## ADDENDUM NO. 2

**PROJECT NAME:** Wick Alumni Center Life Safety & HVAC Improvements  
**UNL PROJECT NUMBER:** C120P021  
**BID INVITATION NUMBER:** 2222-13-7200

**CONSULTANT:** Farris Engineering  
**ADDRESS:** 818 P Street, Suite 100

**DATE OF ISSUANCE:** September 11, 2013  
**DATE OF BID OPENING:** September 18, 2013

**SHEET NO**  
**MD1-2**

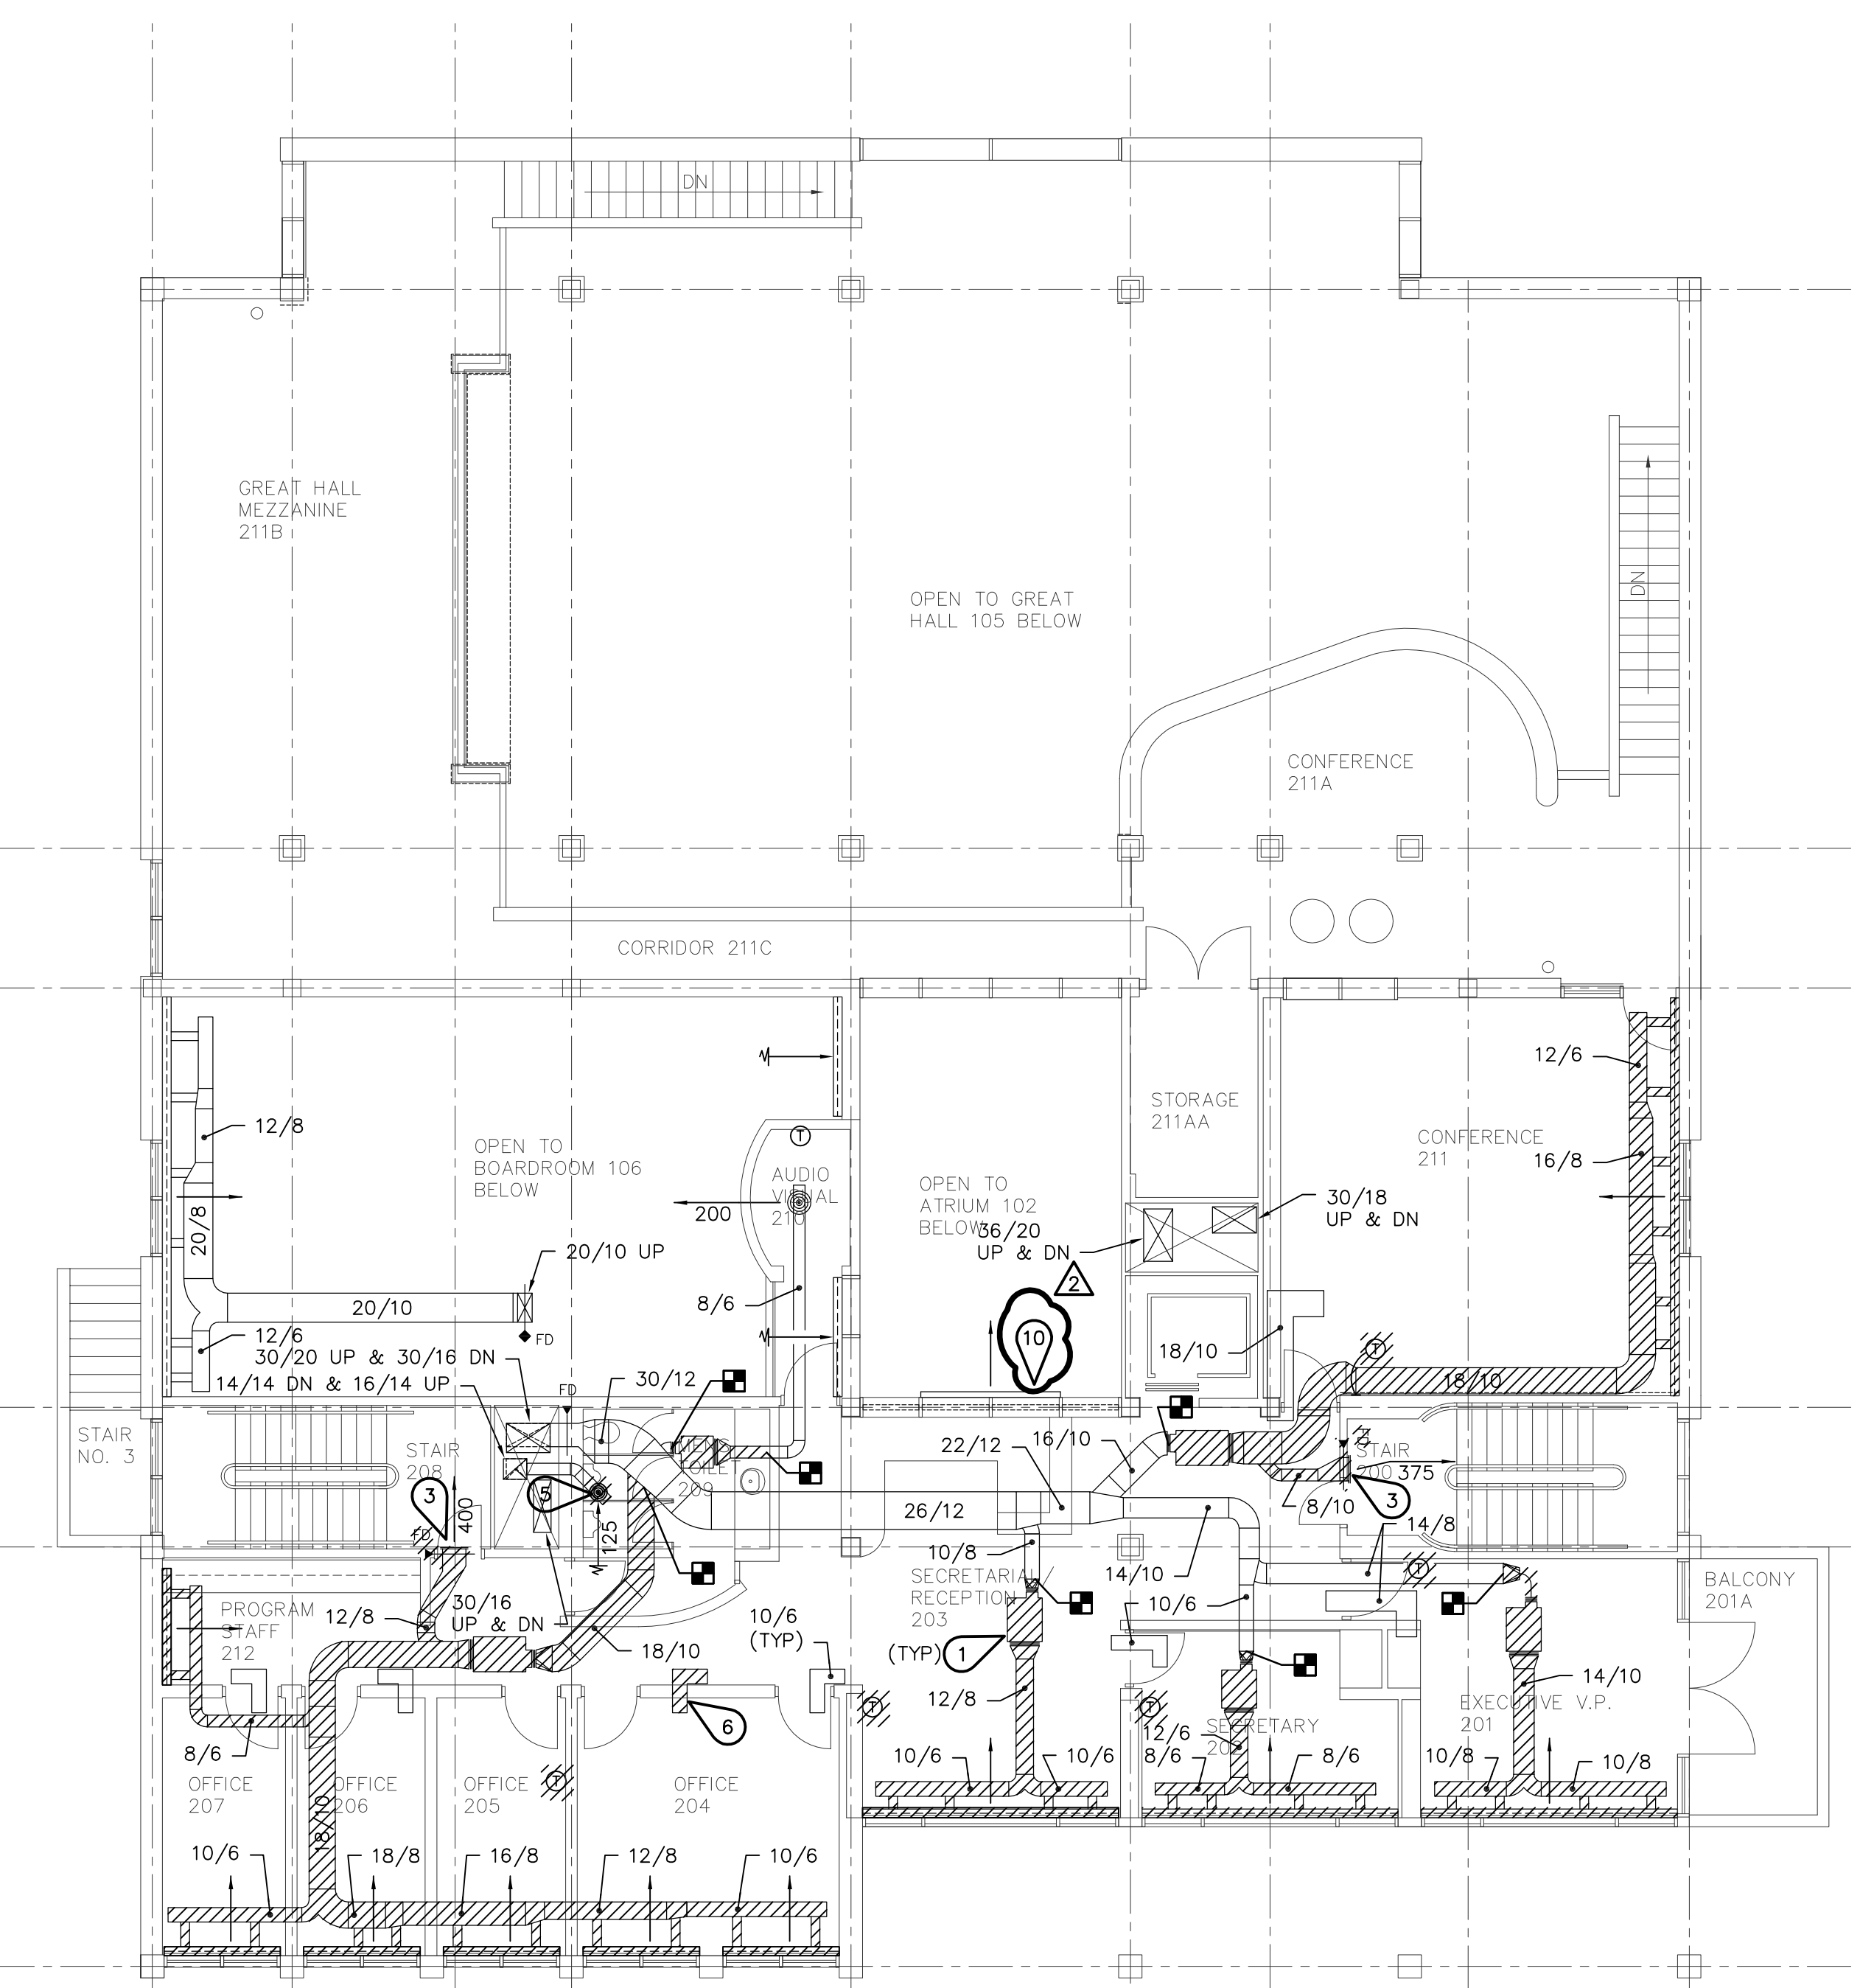
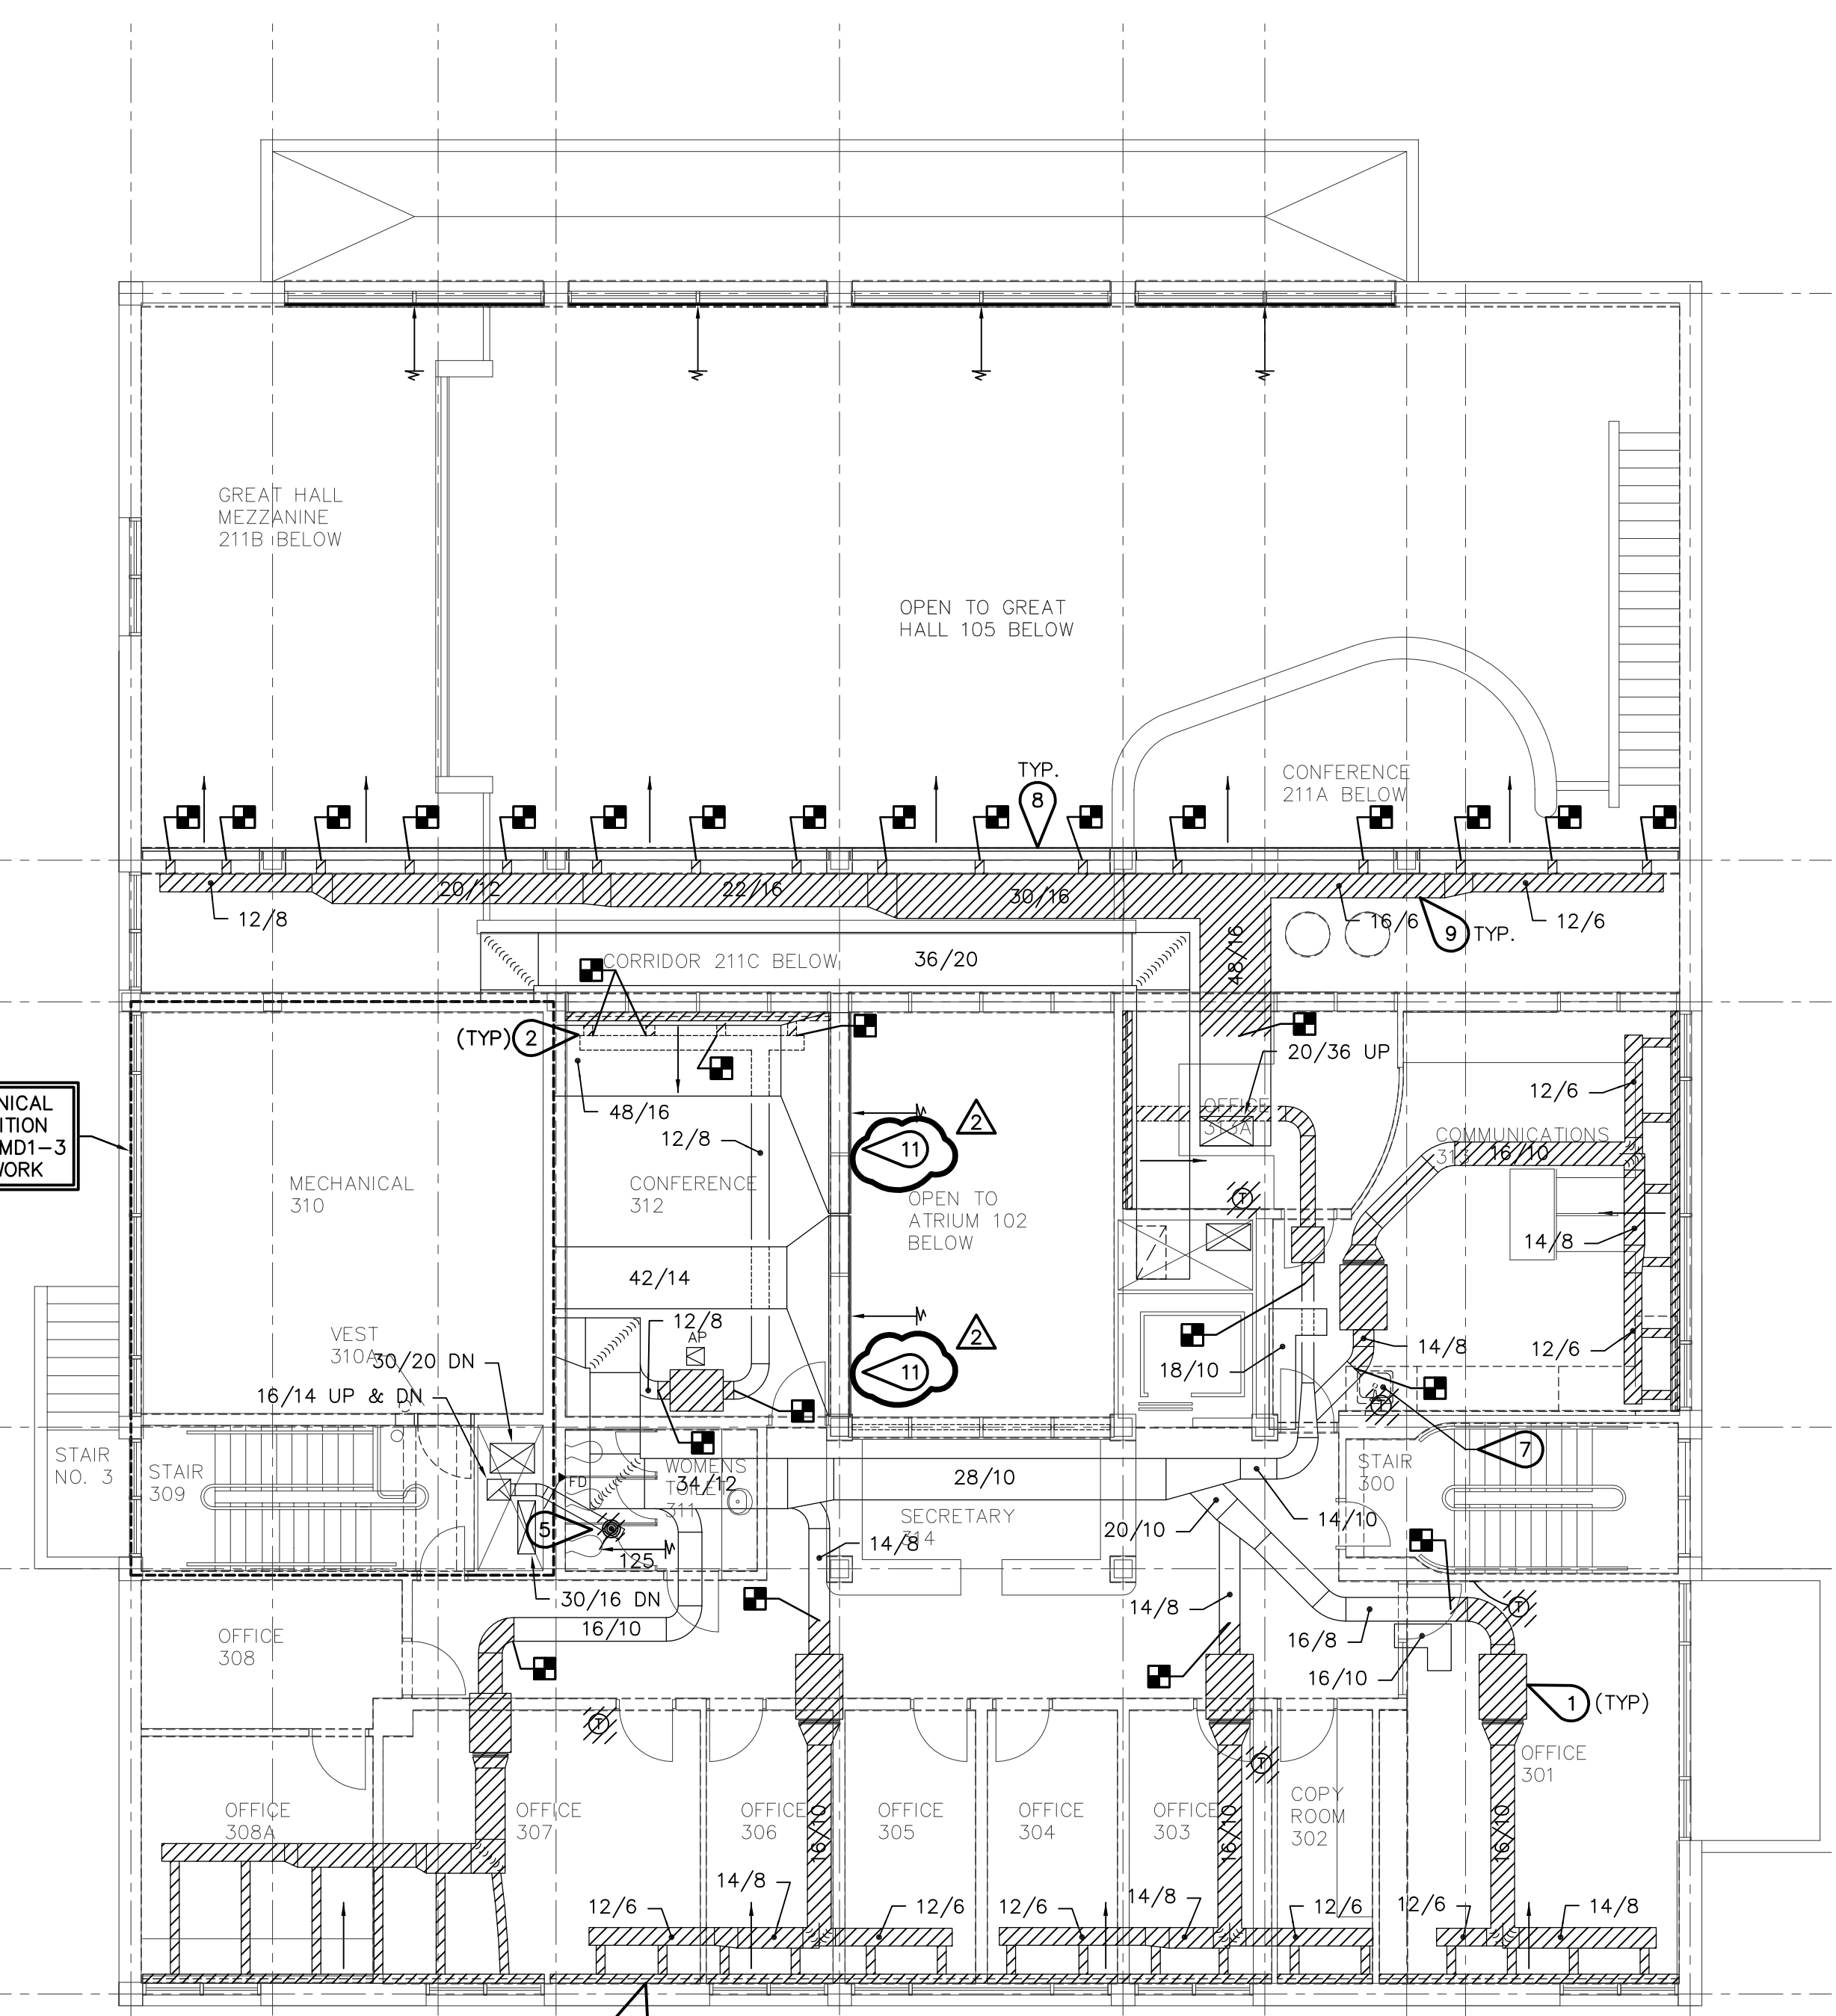
1. This sheet has been reissued in its entirety as a part of Addendum No.2.
2. Mechanical Keynotes #10 and #11 have been added.

- 9 REMOVE EXISTING DUCTWORK AND TAPS FROM MAIN DUCT TO DIFFUSER PLENUM.
- 10 REMOVE EXISTING DECORATIVE GRILLE TO FACILITATE INSTALLATION OF SMOKE/FIRE DAMPER ASSEMBLY. GRILLE TO BE REINSTALLED.

- 11 MODIFY EXISTING DUCTWORK TO ACCOMMODATE NEW SMOKE/FIRE DAMPER, SLEEVE, ACTUATOR AND ACCESSORIES. WHERE DAMPER CANNOT OCCUR WITHIN RATED WALL OR FLOOR, PROVIDE INSULATED SLEEVE PER UL REQUIREMENTS TO MAINTAIN ASSEMBLY RATING. EXISTING DECORATIVE GRILLE TO BE REINSTALLED AFTER INSTALLATION OF SMOKE/FIRE DAMPER ASSEMBLY. PROVIDE SERVICE ACCESS TO DAMPER PER MANUFACTURER'S RECOMMENDATIONS.
